Important Info – June 2017

HOLLAND Fifth Wheel Slider Assemblies

Retirement of Traditional Fifth Wheel Slider Base

HOLLAND Severe-Duty Slider Features

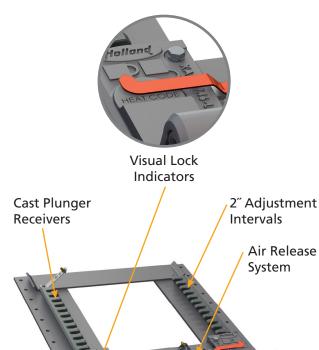
As of July 1, 2017, SAF-HOLLAND will launch the new Severe-Duty Slider (SDS), a modular designed slide base utilizing the latest engineering and manufacturing processes. The new SDS will feature increased vertical capacity, slider air release system, inboard and optional outboard mounting, and slide lengths available every 12", up to 72" of travel.

SAF-HOLLAND engineers developed the SDS to replace the traditional, older design heavy-duty slider. This includes the following heavy-duty variants: FW2570, FW2555, FW7090, and FW35-7xxx. The SDS will now be produced with a new robotically controlled manufacturing process. All orders for heavy-duty sliders placed after June 9 will be transitioned to the new SDS.

Effective with the release of the SDS, SAF-HOLLAND will no longer provide non-ILS traditional 7000 Series and 8000 Series sliders equipped with HOLLAND fifth wheel assemblies. In most cases, these 7000 Series and 8000 Series sliders can be replaced with the ILS, and in some limited cases replaced with the SDS. There will be limited availability of tradition non-ILS sliders through the aftermarket for service needs.

SAF-HOLLAND sales personnel will notify customers who currently specify the traditional slide base equipped top plates and will provide them with an ILS or the new Severe-Duty Slider (SDS). 7000 and 8000 Series traditional sliders will be replaced with the ILS slider and FW2570, FW2555, FW7090, and FW35-7xxx will be replaced by ILS or SDS, depending on applications requirements. Any slider base in excess of 48″ slide travel length will require the SDS. The SDS will be available with the patented HOLLAND KOMPENSATOR® for rigid tank trailers and will have an optional No-Tilt model, available later this summer.
